# M-13 Revision 93

Kevin Hatch  
System Operations Subcommittee  
Second Read – July 2, 2024  
Sr. Manager Dispatch, System Operations

## **M-13 Version 93 Revisions**

- Attachment E: Manual Load Dump Allocation Tables
- Annual update of table
- Added note for recent EOP-011-4 Emergency Operations Standard update

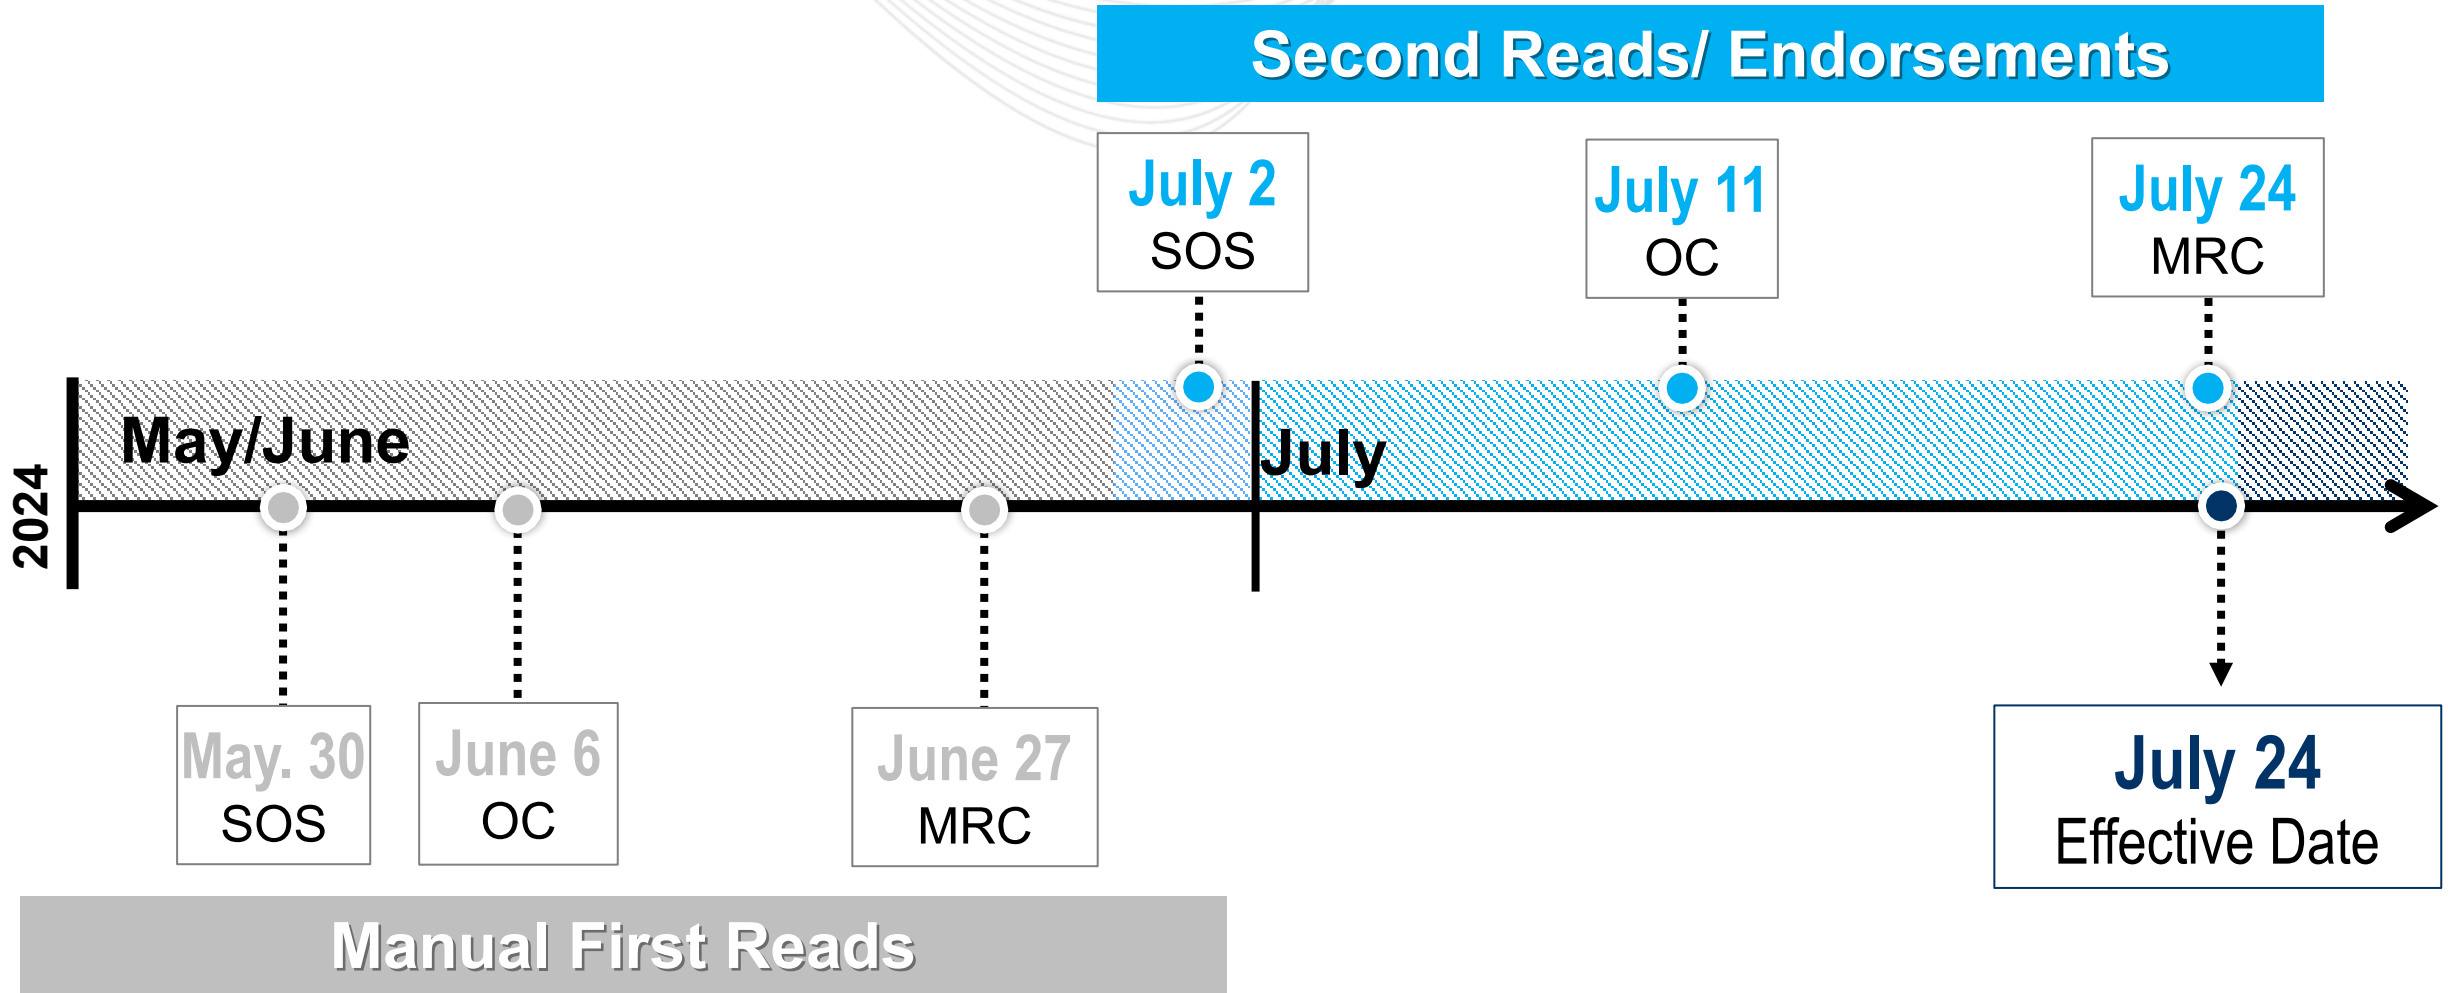
In accordance with NERC Reliability Standard EOP-011-4 R7, PJM as the Transmission Operator, has identified in PJM M13 Emergency Operations, Attachment E: Manual Load Dump Allocation Tables, Attachment F: PJM Manual Load Dump Capability, and PJM M36 System Restoration, Attachment H: Under Frequency Load Shed (UFLS) Tables, the Distribution Providers, UFLS-Only Distribution Providers and Transmission Owners, as entities that are required to assist with the mitigation of operating Emergencies in its Transmission Operator Area through operator-controlled manual Load shedding, undervoltage Load shedding, or underfrequency Load shedding
